# HISTORIC AND DESIGN REVIEW COMMISSION

June 05, 2019

**HDRC CASE NO:** 2019-313  
**ADDRESS:** 801 LABOR  
**LEGAL DESCRIPTION:** NCB 733 BLK 5 LOT 8 & N 50 FT OF 7 ARB A8  
**ZONING:** RM-4,H  
**CITY COUNCIL DIST.:** 1  
**DISTRICT:** Lavaca Historic District  
**APPLICANT:** Ernesto Urbano/Urban Stone Custom Builders LLC.  
**OWNER:** Manuel Esparza  
**TYPE OF WORK:** Roof replacement, fenestration modifications, porch modifications  
**APPLICATION RECEIVED:** May 15, 2019  
**60-DAY REVIEW:** July 14, 2019  
**CASE MANAGER:** Stephanie Phillips  
**REQUEST:**

801 Labor 78210

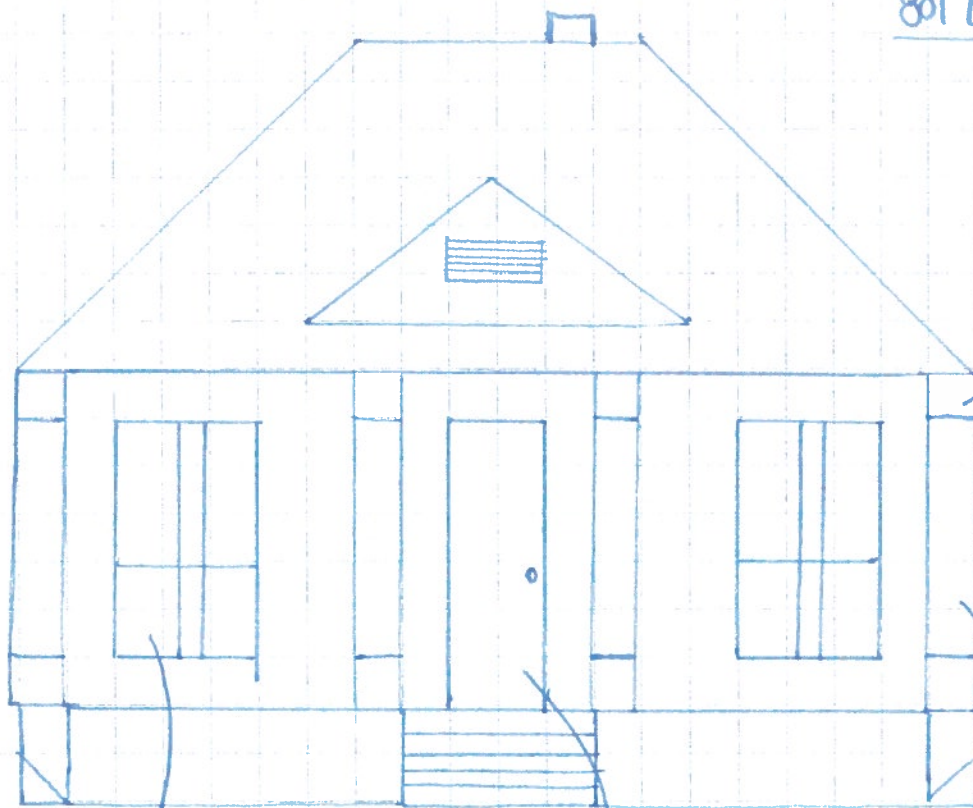
- b. PORCH COLUMNS – The applicant has proposed to enclose the existing non-original wrought iron columns with wood to create wood box columns. Based on the applicant’s submitted documents, the proposed columns are to be 20 by 20 inches in width. While staff generally finds the replacement of the non-original columns with simple wood columns to be consistent with the Guidelines, staff does not find 20 by 20 inch width columns appropriate. Based on the style of the home and historic precedents in the district, staff finds a simple wood column measuring a maximum of 6 by 6 inches to be appropriate.

Proposed Columns  
Wrapped in Wood/Siding  
to restore to original look.  
Roughly 20" x 20" in size

Item 1, Staff recommends approval of the front porch column modifications based on finding b with the following stipulations:

- i. That the columns be no wider than 6x6". The applicant is required to submit a detailed elevation and plan drawing that clearly indicates all relevant dimensions for staff review and approval prior to obtaining a Certificate of Appropriateness.
